**PLANNED UNIT DEVELOPMENT &
SUBDIVISION STAFF REPORT****Date: May 19, 2005**

<u>DEVELOPMENT NAME</u>	Forest Cove Subdivision, Unit Three and Unit Four
<u>SUBDIVISION NAME</u>	Forest Cove Subdivision, Unit Three and Unit Four
<u>LOCATION</u>	South side of Tulane Drive, 125'± East of Belle Wood Drive East, extending to the West side of Forest Dell Road, 725'± North of its South terminus.
<u>CITY COUNCIL DISTRICT</u>	District 7
<u>PRESENT ZONING</u>	R-1, Single-Family Residential
<u>AREA OF PROPERTY</u>	137 lots / 44.4± acres
<u>CONTEMPLATED USE</u>	Reduced lot widths and sizes, reduced building setbacks, and increased site coverage in a single-family subdivision.
<u>TIME SCHEDULE FOR DEVELOPMENT</u>	Immediate
<u>ENGINEERING COMMENTS</u>	Must comply with all stormwater and flood control ordinances. Any work performed in the right of way will require a right of way permit.
<u>TRAFFIC ENGINEERING COMMENTS</u>	Driveway number, sizes, location and design to be approved by Traffic Engineering and conform to AASHTO standards.

APPLICATION NUMBER 4, 5 DATE May 19, 2005
APPLICANT Forest Cove Subdivision, Unit Three and Unit Four
REQUEST Planned Unit Development and Subdivision

SITE PLAN

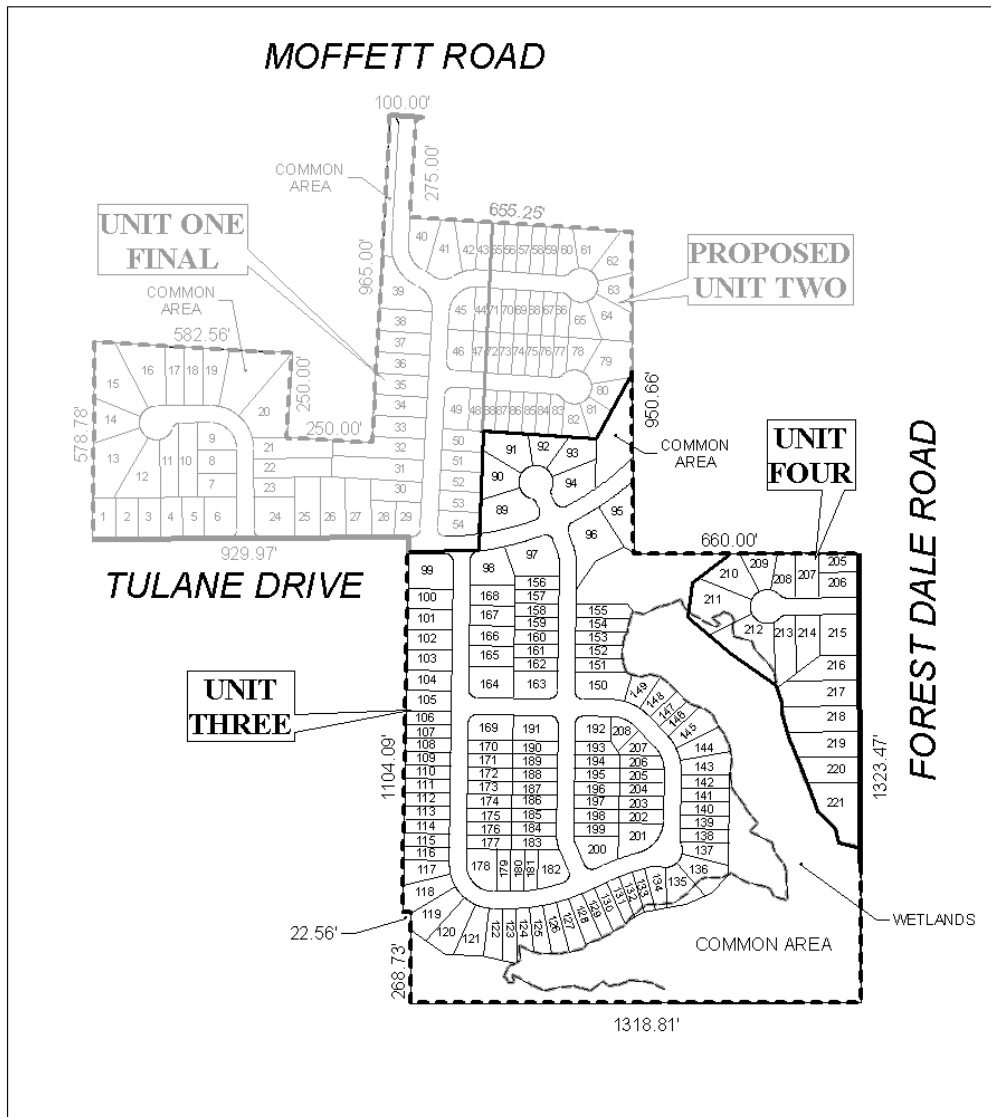
In terms of access and roads there is some concern. First, Tulane from Forest Cove Drive eastward is essentially a driveway, thus the road in this area must be improved to city standards. Furthermore, the provision of a cul de sac at the East end of Tulane Drive should be required.

The site contains wetlands thus the area could be considered environmentally sensitive, therefore, the approval of all applicable federal, state and local agencies would be required. Regarding the common areas, a note should be placed on the final plat stating that the maintenance of the common areas shall be responsibility of the property owners.

Subdivision: With modifications, and a waiver of Section V.D.2., the plat will meet the minimum requirements of the Subdivision Regulations and is recommended for Tentative Approval subject to the following conditions: 1) construction of Tulane Drive to city standards; 2) the provision of a cul de sac at the East end of Tulane Drive; 3) the obtaining of all applicable federal, state and local approvals; 4) certification that the stormwater detention system will accommodate the additional site coverage; 5) full compliance with all municipal codes and ordinances; and 6) placement of a note on the final plat stating that the maintenance of all common areas shall be the responsibility of the property owners

TYPICAL LOT DETAIL FOR SETBACKS

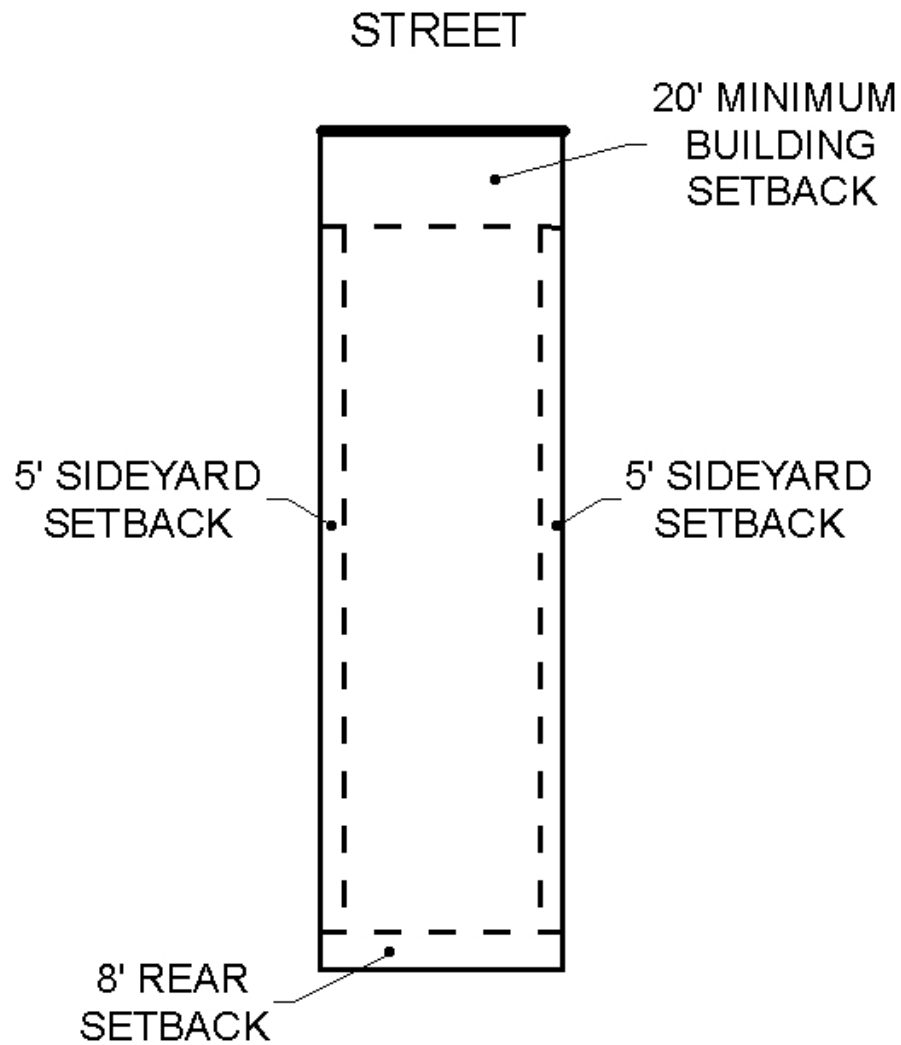
The applicant still proposes reduced lot widths and lot sizes. In terms of the request for reduced setbacks, the applicant proposes a 20-foot front yard setback, and five-foot side yard setbacks. This would provide a minimum of 10-feet between homes and are typical side yards for garden homes in a residential PUD and these minimum setbacks should be illustrated on the final plat. The applicant is also requesting 47.5% site coverage, which again is a typical request for a residential PUD subject to the certification of adequate capacity for the stormwater detention system.
